**CITY OF AUSTIN
Board of Adjustment
Decision Sheet**

CASE NUMBER: C15-2017-0047

ADDRESS: 3602 & 3604 RIVERCREST DR

Wetlands Biologist Review - Liz Johnston - 512-974-2619

3602 & 3604 Rivercrest Drive
CUT/FILL XSECS
& CALCULATIONS

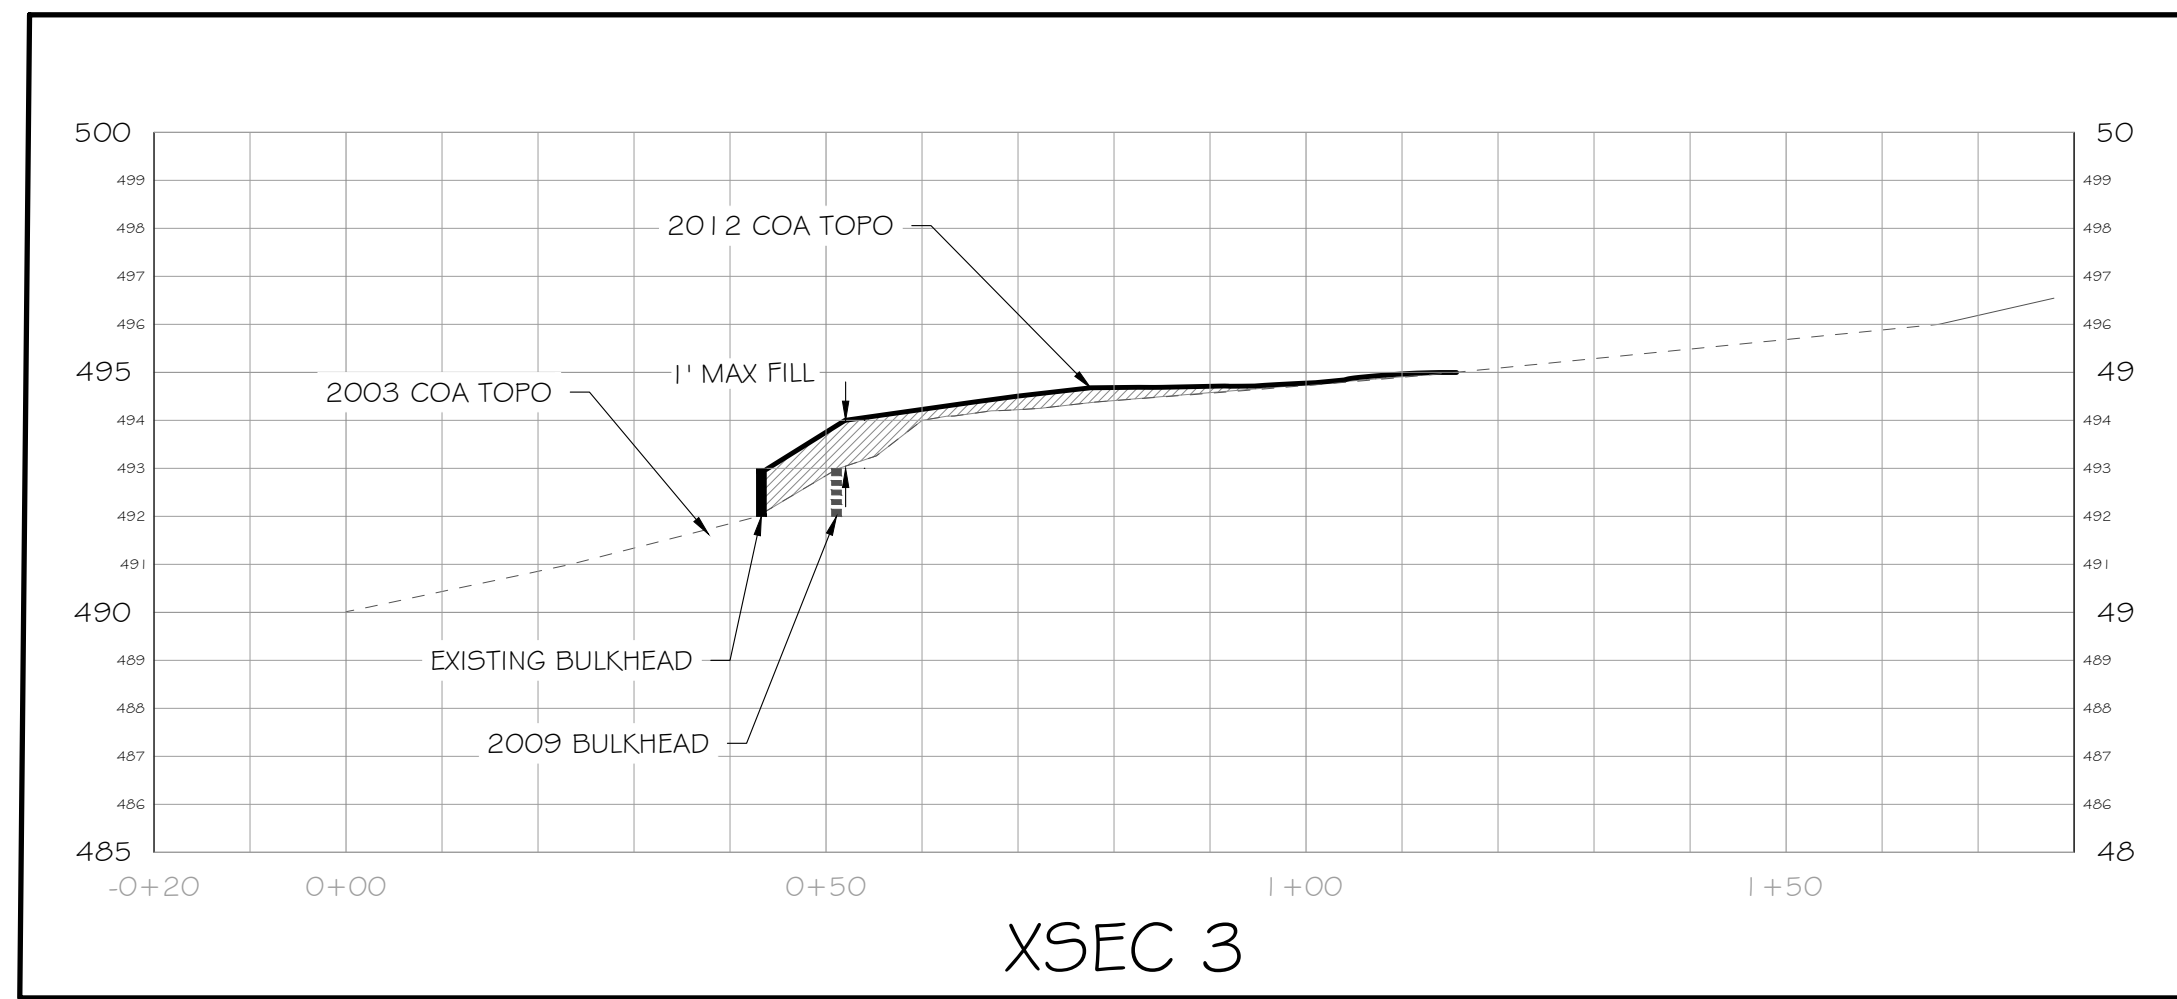
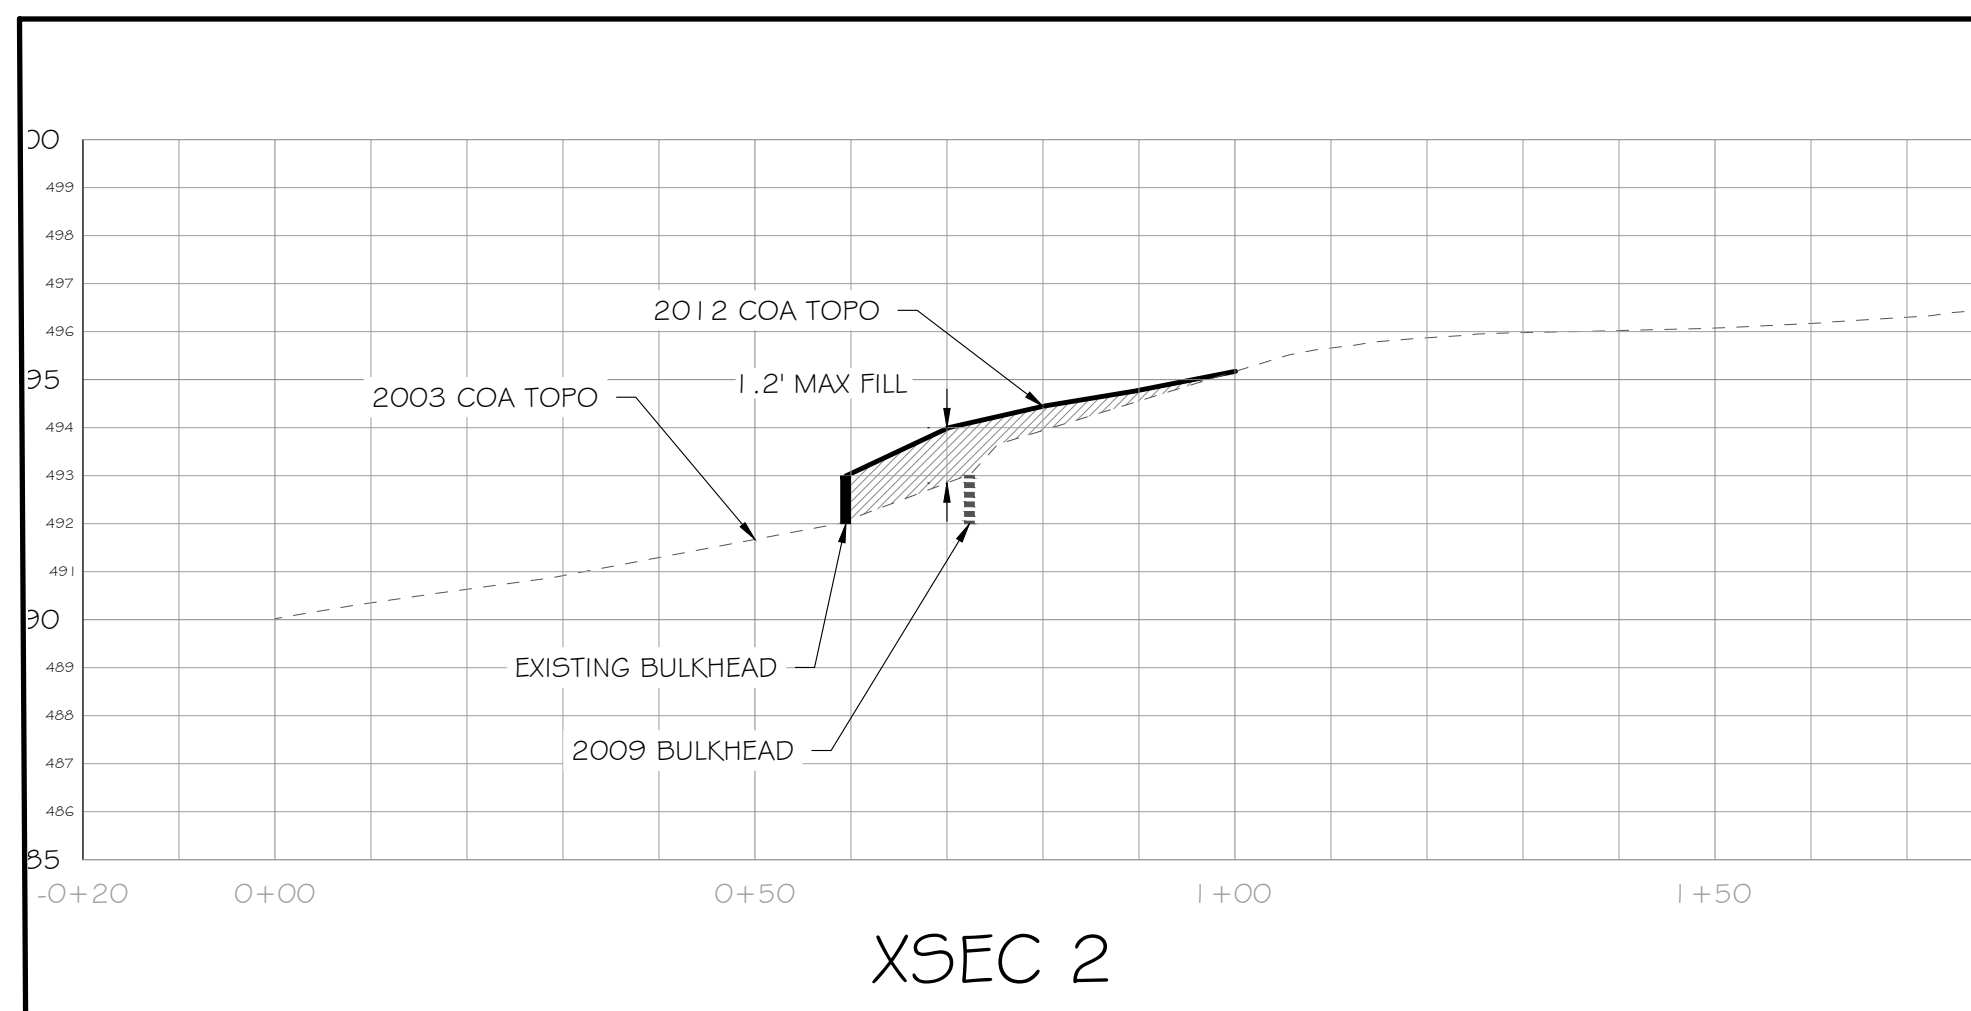
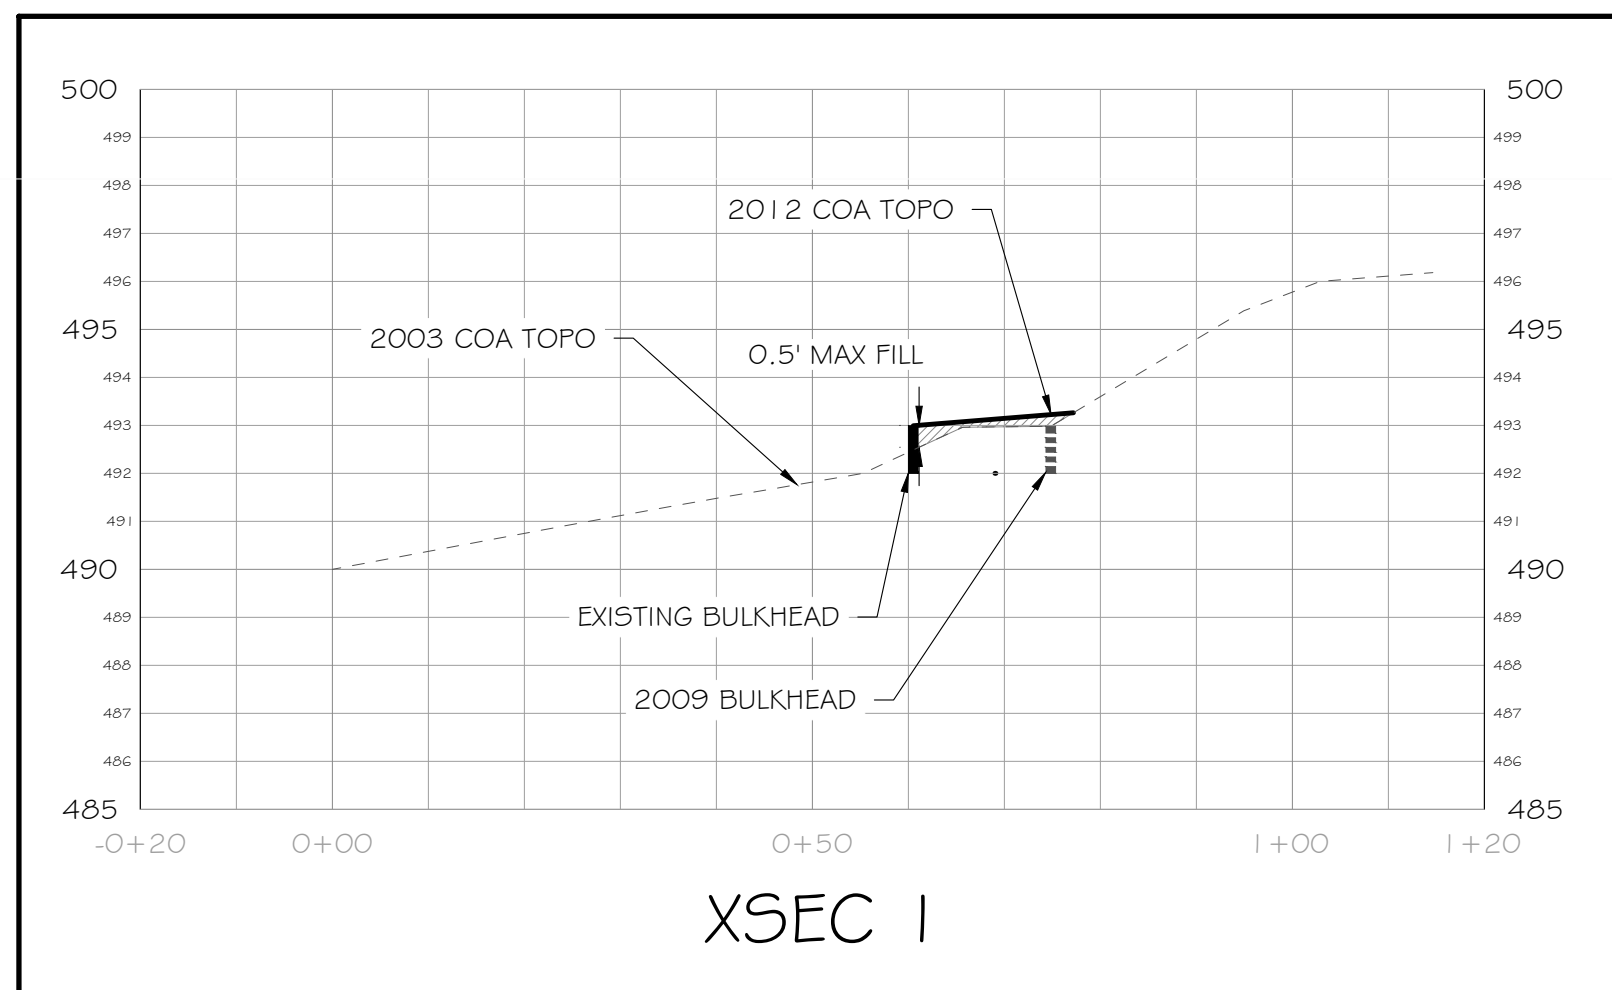
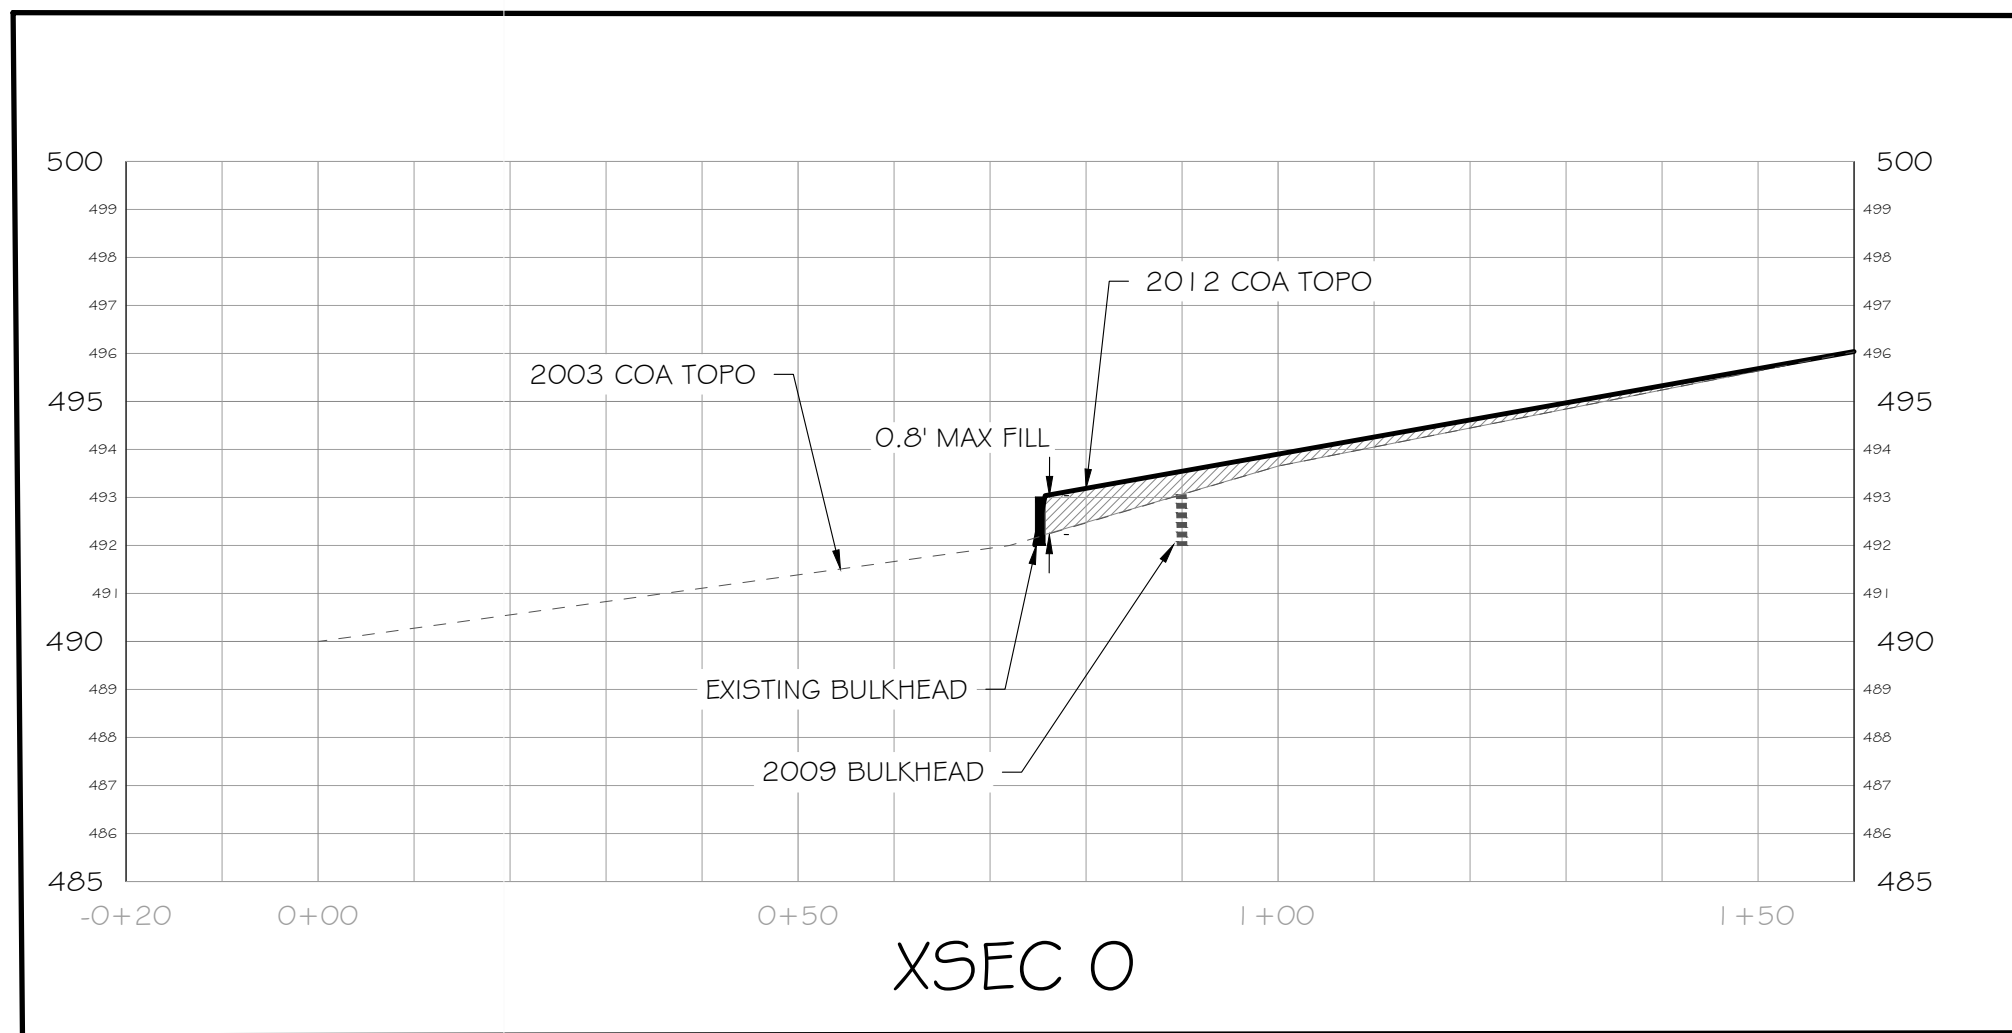
WB 3 Update 0 Provide accurate bathymetric profile information demonstrating how the 20 cubic yard dredging estimate was calculated.

Update 1: Show the dredging profile on the architectural elevation. **SEE SHEET 2**

3602 Rivercrest Drive
ATTACHMENT I

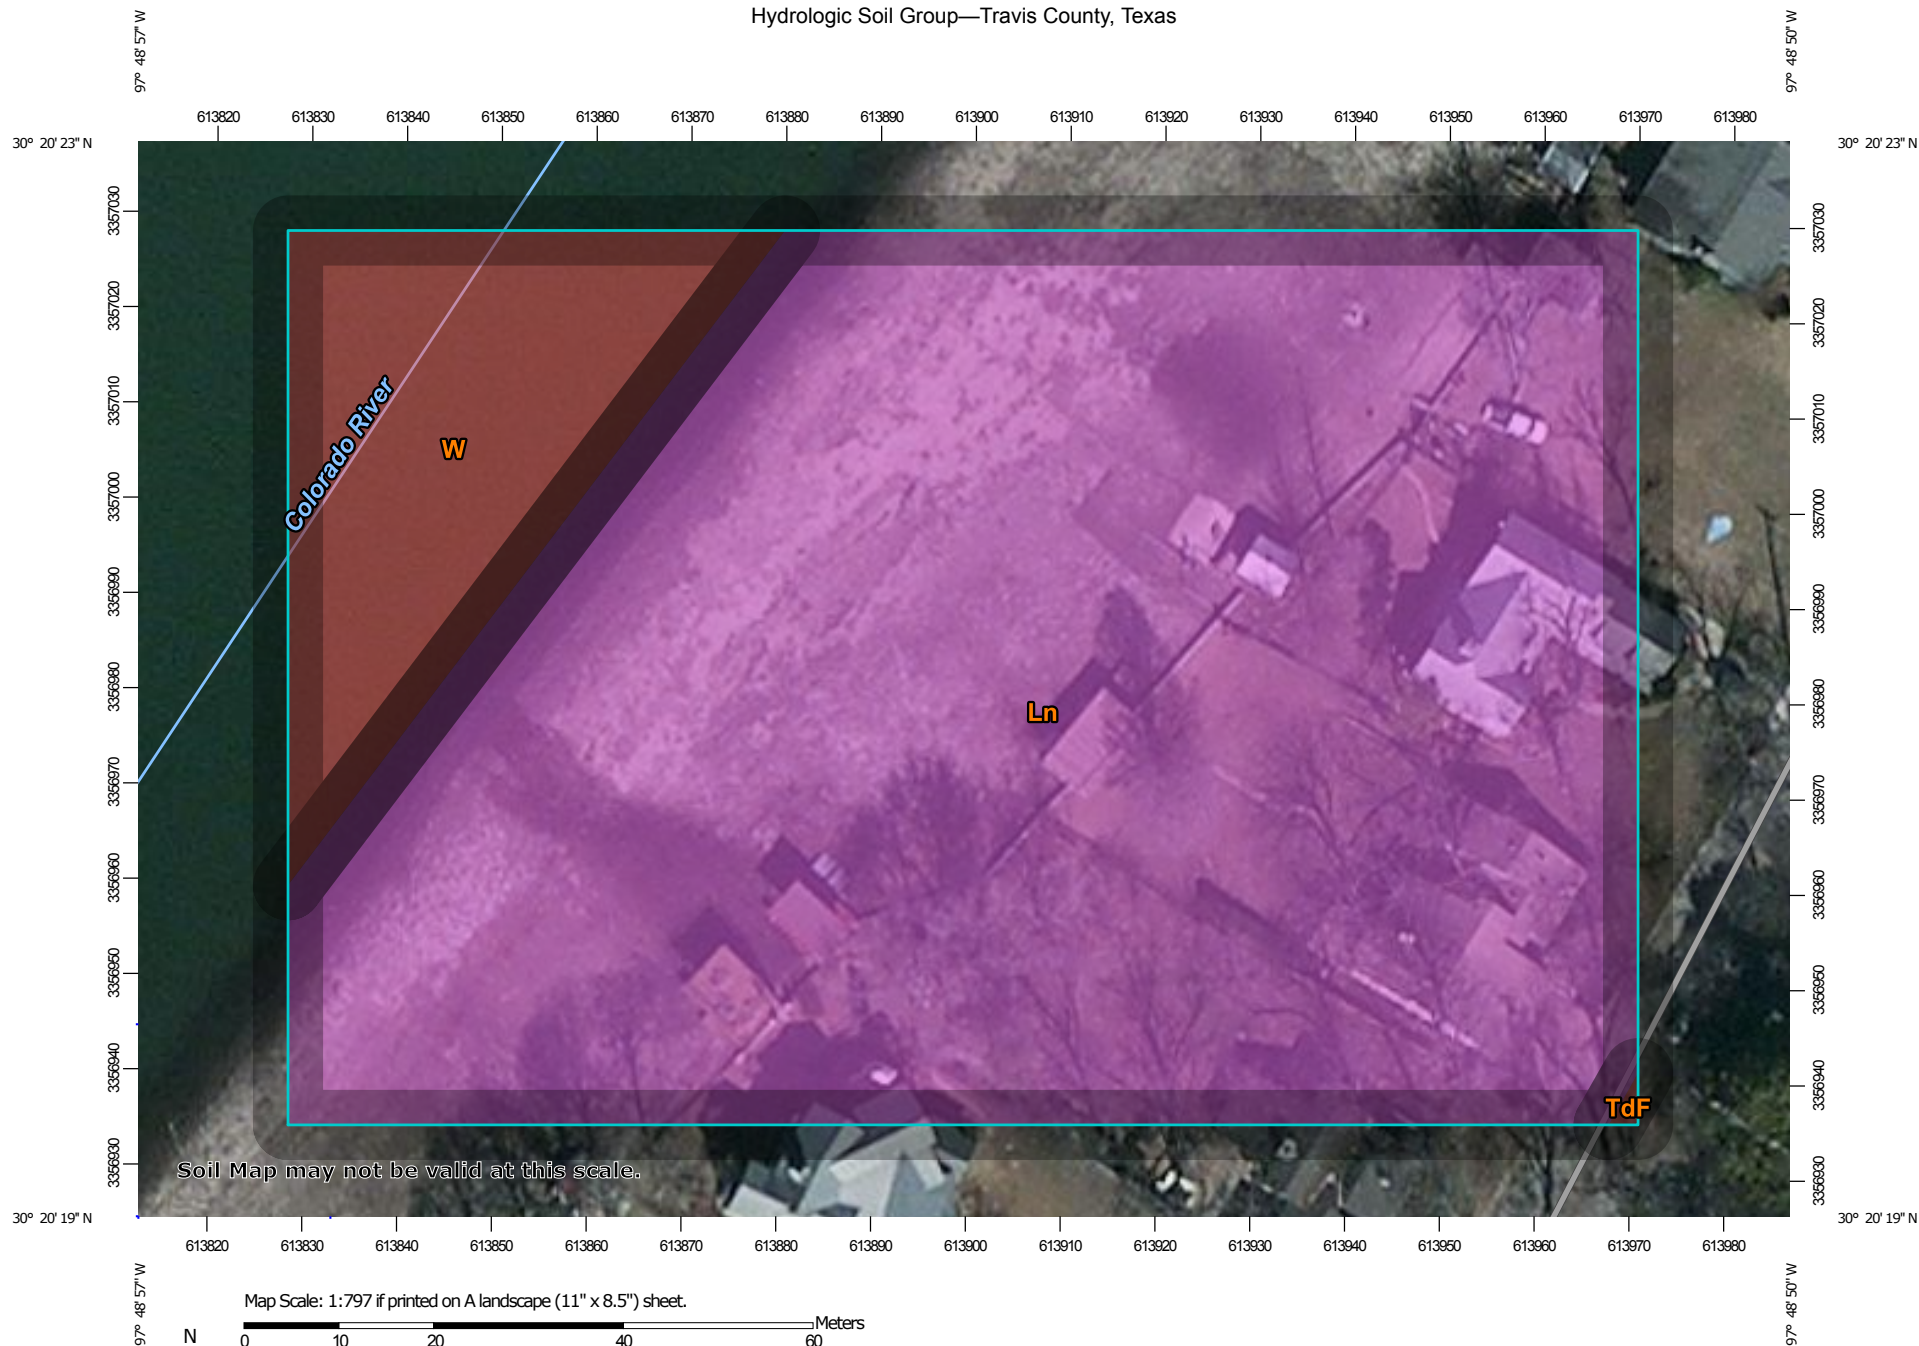
- Provide a Functional Assessment due to the unpermitted floodplain modification. **EXISTING AND PROPOSED FAFH ATTACHED**
- There is one wetland CEF located adjacent to the property at the upstream property boundary which was identified during the 2013 review which exclusively included *Colocasia esculenta* and *Salix nigra* wetland species, please revise Part 8 accordingly
- Please revise Part 9 to include wetland on map (as described above)
- Please complete Grass table in part 11
- Please check box YES for hydrophytic vegetation and include Bald Cypress (*Taxodium distichum*) in hydrophytic species table
